**SUNSHINE CANYON
LANDFILL EXTENTION**

**RESPONSES TO PRE-CIRCULATION COMMENTS
FROM COUNTY AGENCIES**

RESPONSES TO COMMENTS FROM COUNTY AGENCIES
ON DRAFT EIR PRIOR TO PUBLIC CIRCULATION

7
(REVISED)

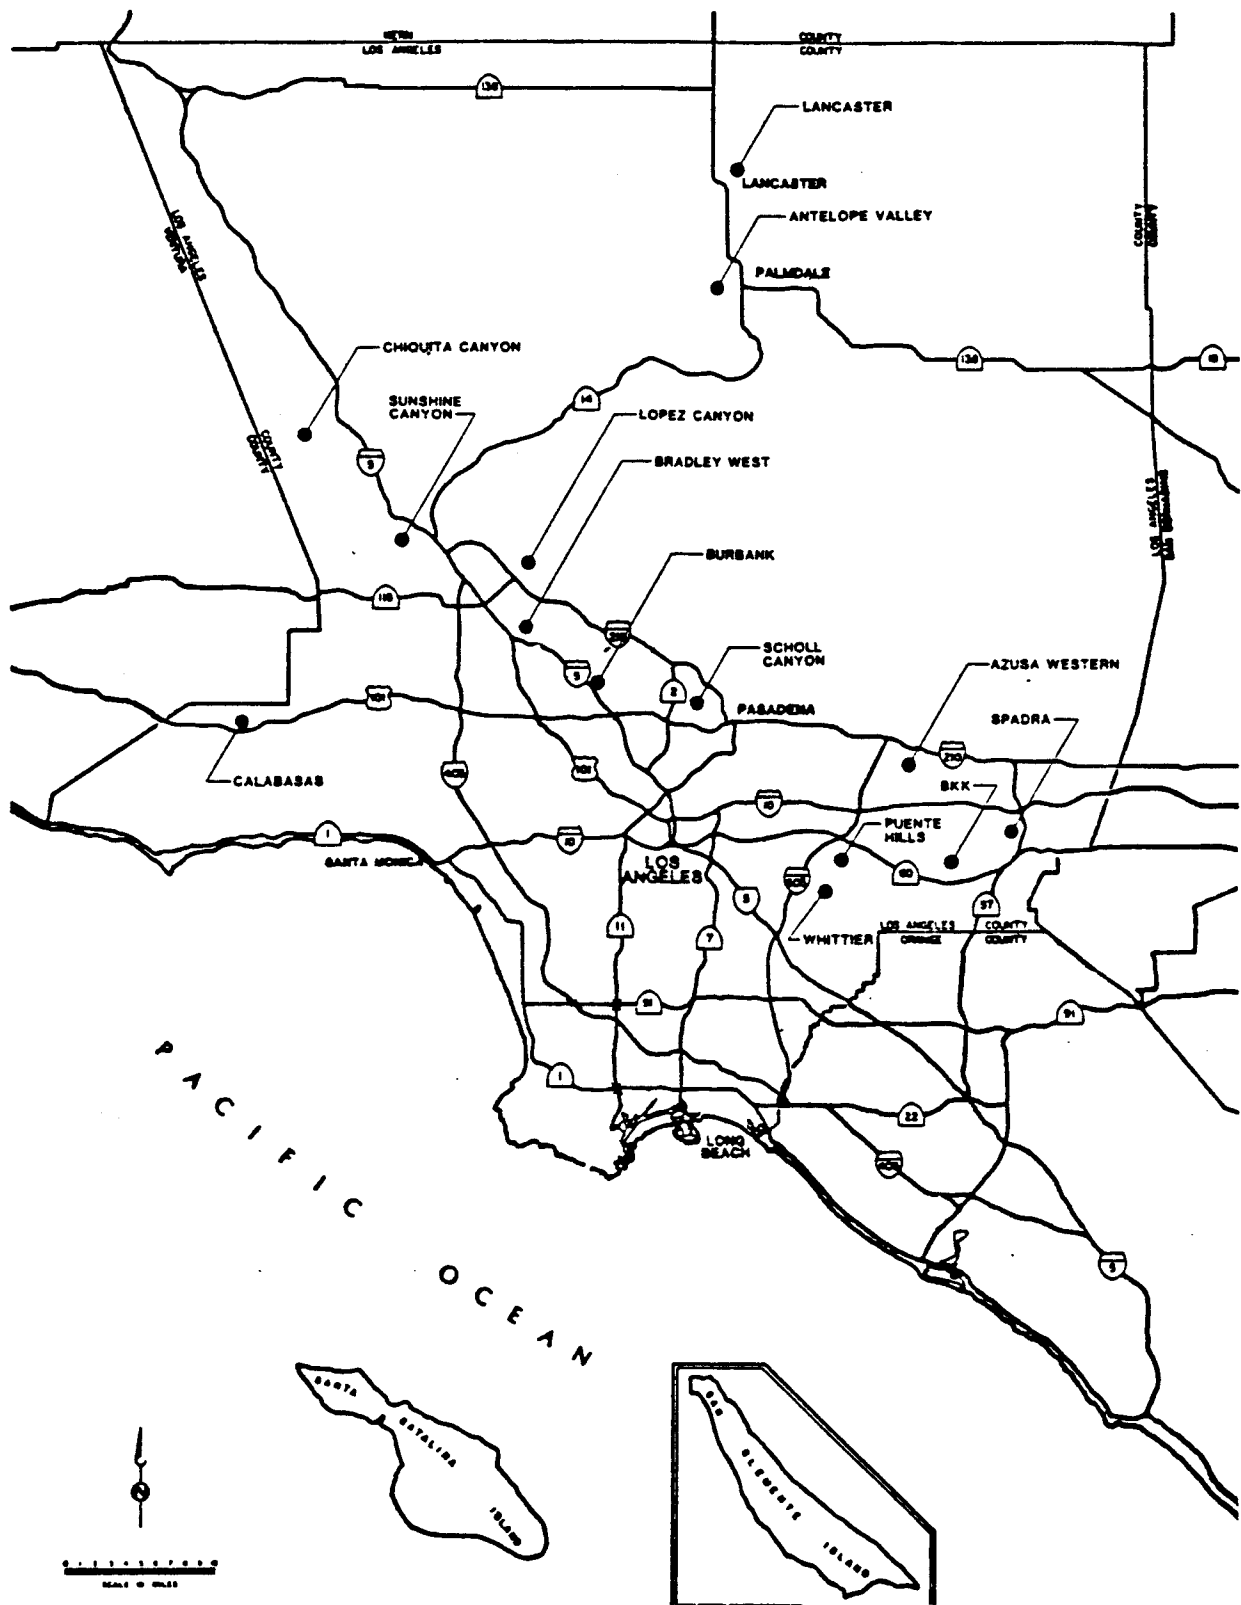
Comment 2: Page 32, Figure 7: The figure should be revised to exclude the closed landfills.

Response 2: Figure 7 has been revised as suggested and is provided on the following page.
